# Access Compliance Report

## Public Rights-of-Way

### (Curb Ramps)

Intersection ID: 48984	Main Street: ASHTON_GATE_DR	Cross Street: KINGSDOWN_AV	Location: NE
ADA ID: 3D9EE9A1AA86	Ramp Type: BlendTrans2	Initial Pass/Fail: Pass	Overall Compliance: No
		Severity Score: 0

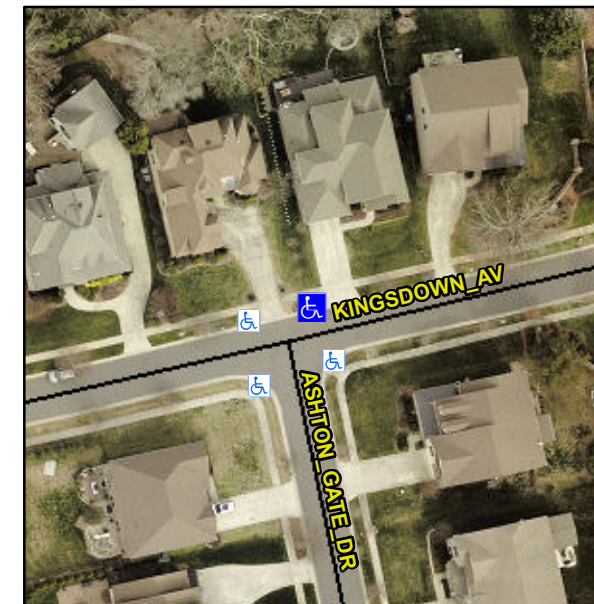
N/A	Ramp inside XWalk1?	N/A	N/A	Ramp inside XWalk2?	N/A
	Road Slope (%)	0.2		Clear Space?	Yes
	Road X Slope (%)	0.0	N/A	Clear Space to XWalk (in)	N/A
Yes	Any Obstructions?	No	Yes	Storm Grate/Utility Hazard?	No
	Obstruction Type			Storm Grate/Utility Type	
		N/A			N/A
			Yes	Surface Condition? (G/P)	Good
			No	Curb Slope (%)	5.2

**Remove & Replace Curb Slope and Extend Ramp.**
